**RE: Site Plan & Conditional Use Application  
3400 Lafayette Road, Portsmouth, NH  
Tax Map 297, Lot 11  
JBE Project No. 20737**

**RE: TAC & Conservation Commission Comments  
3400 Lafayette Road, Portsmouth, NH  
Tax Map 297, Lot 11  
JBE Project No. 20737**

We have received approval from the Conservation Commission and TAC with certain conditions. We have revised the plans accordingly for the items we could modify and others may have to be conditions of approval. Original review comments are italicized, and we offer the following responses below:

SHEET 6 OF 22  
JBE PROJECT NO. 20737

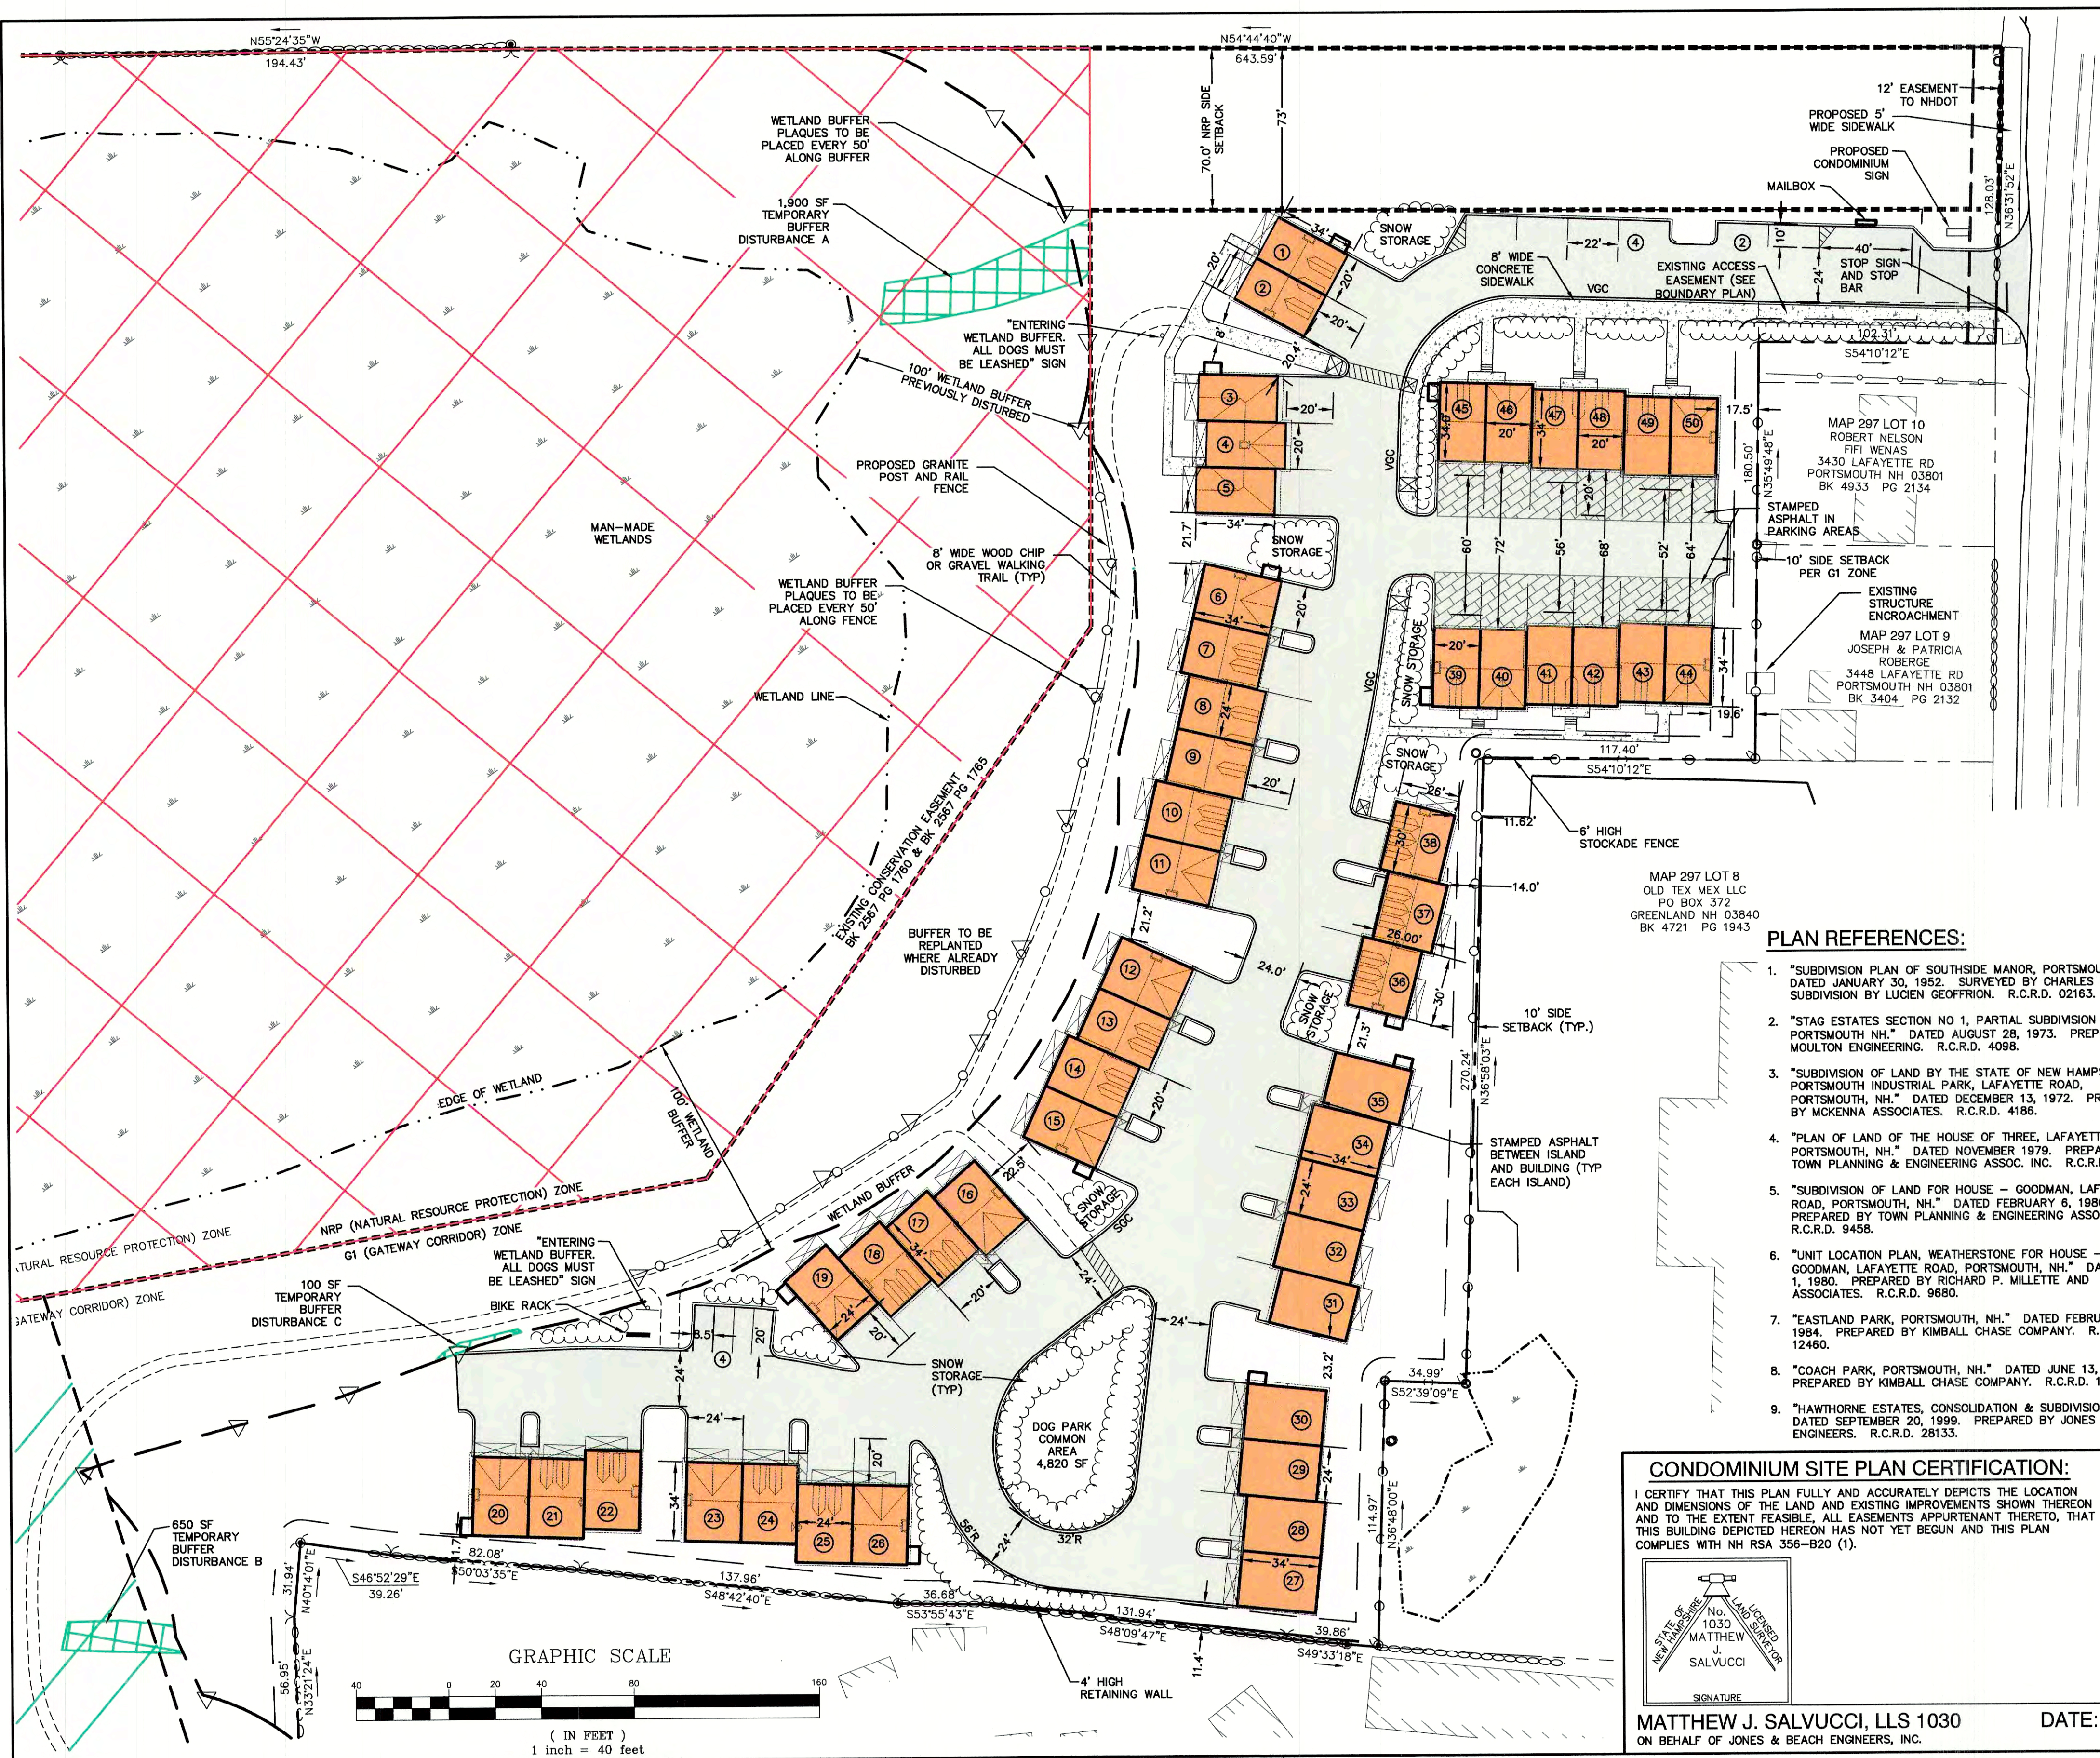
2. *Trailhead connections and wayfinding signs will be included for residents on the eastern side of the development to access the recreational trails.*

4. *The applicant shall provide signage for the wetland buffer designating its location and requiring all dogs to be leashed.*

**RESPONSE: The above note is already on the plans as Note #20 on Sheet C2.**

**RESPONSE: Trailhead signage has been added to the Sheet C2 at the two trail access locations.**
3. *Deeded public access will be provided to the proposed open space and undeveloped portion of the property that abuts city owned parcels.*

**RESPONSE:** Signs stating the above have been added at the two trail access locations on the site.
